Development Site Plan #2007-0003

Woodmont Park Apartments
5400 & 5514 N. Morgan Street and
1151 N. Beauregard Street
North Beauregard Associates

Planning Commission Meeting
May 6, 2008

Docket Item #8
DEVELOPMENT SITE PLAN #2007-0003
WOODMONT PARK

Figure 1. Diagram of existing/restriped and new parking areas.

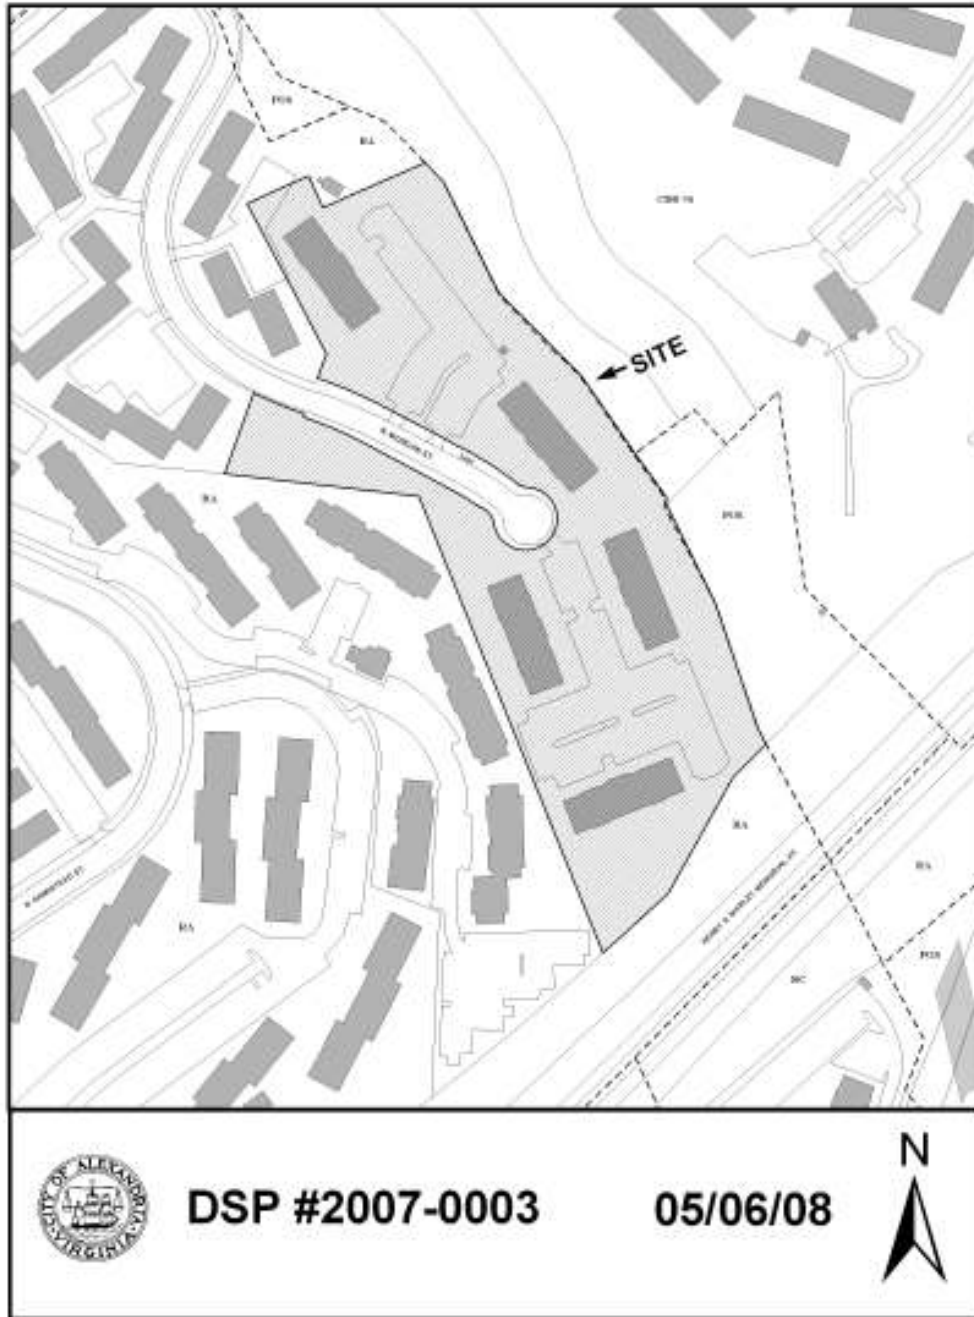
The applicant is proposing to increase the ratio parking to a 1.35 ratio, for a total of 636 spaces. Because the use was constructed prior to the current parking requirements, the existing facility does not have to comply with the current parking requirements. The proposed parking increase would result in a reconfiguration/expansion of existing surface parking lots and the addition of new parking lots as shown in Figure 1.

Figure 3. Beauregard Street landscape buffer

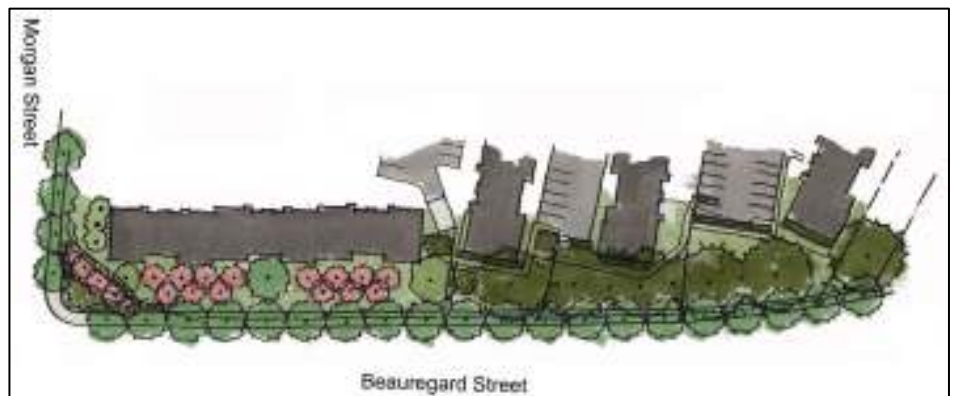
To screen the parking lots along Beauregard Street from street view, the applicant has agreed to provide a wide, densely planted landscape buffer, which will reduce visibility of the parking lots as seen from the street. The applicant has agreed to plant additional street trees in coordination with existing street trees along Beauregard Street south of the Morgan Street intersection. As depicted in Figure 3, additional plant material will be planted in this area,

and together with the new street trees, views of the parking lots along Beauregard Street will be minimized. Staff has also worked with the applicant to push the parking lots as feasibly possible from Beauregard Street.

- a. Augment the existing landscaping between Beauregard Street and the buildings/parking lots with a mix of trees, shrubs and evergreens as generally depicted on *Attachment #4*.

Attachment #2

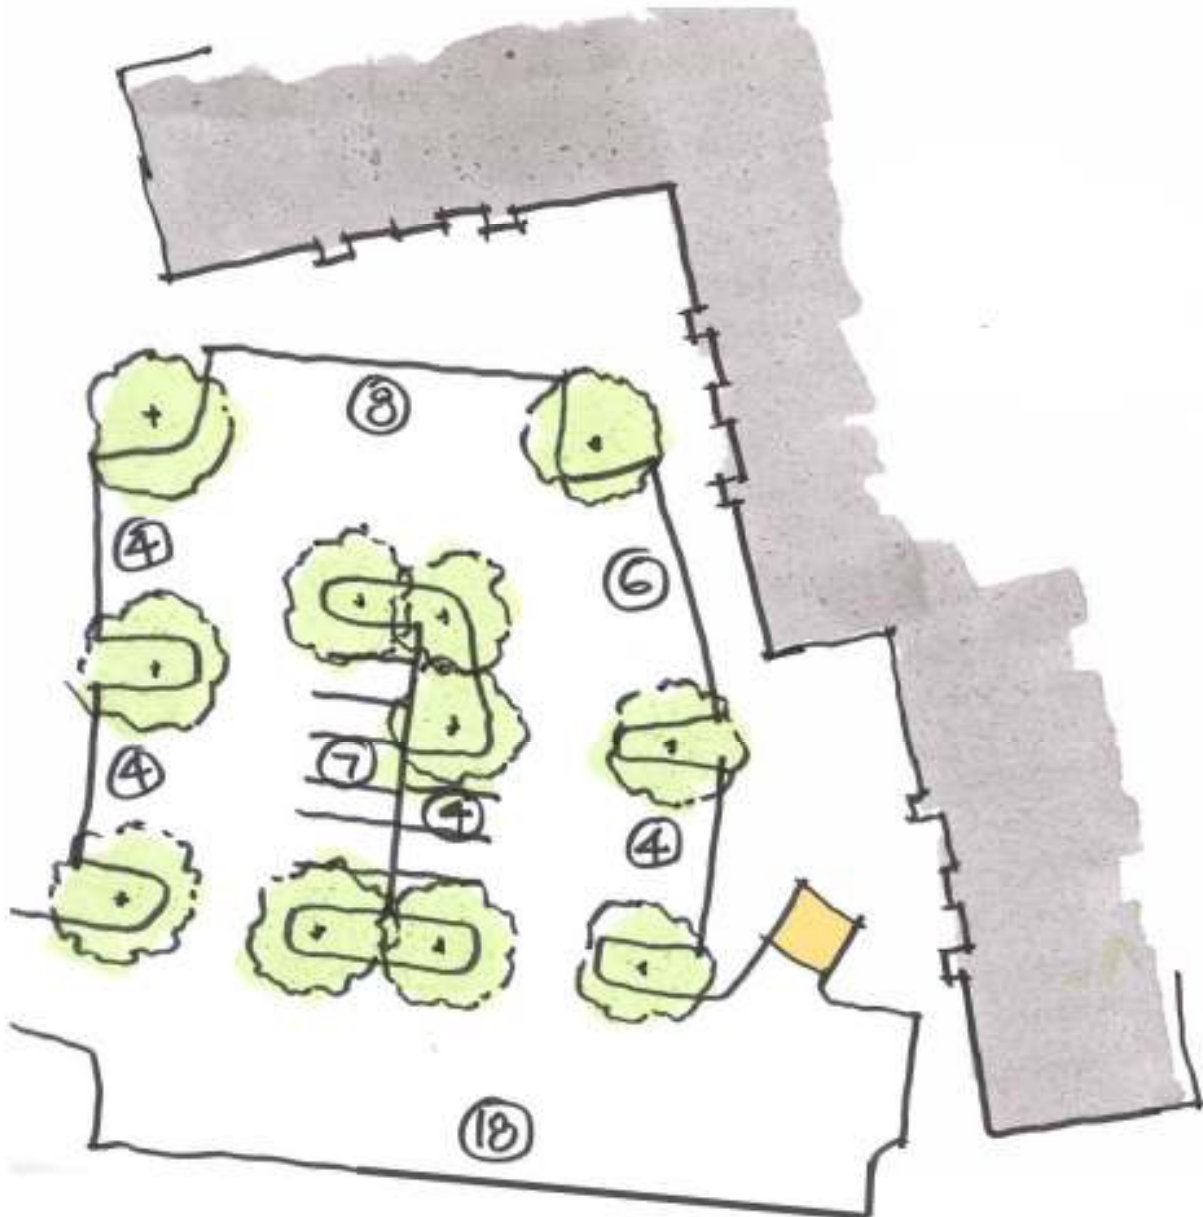
- a. Additional parking spaces in Lots #3, #5 and #9 as generally depicted in *Attachments # 1-3*.
 - b. The setback between the buildings and the drive aisles shall be a minimum of 2 ft. to provide sufficient vehicle overhang.
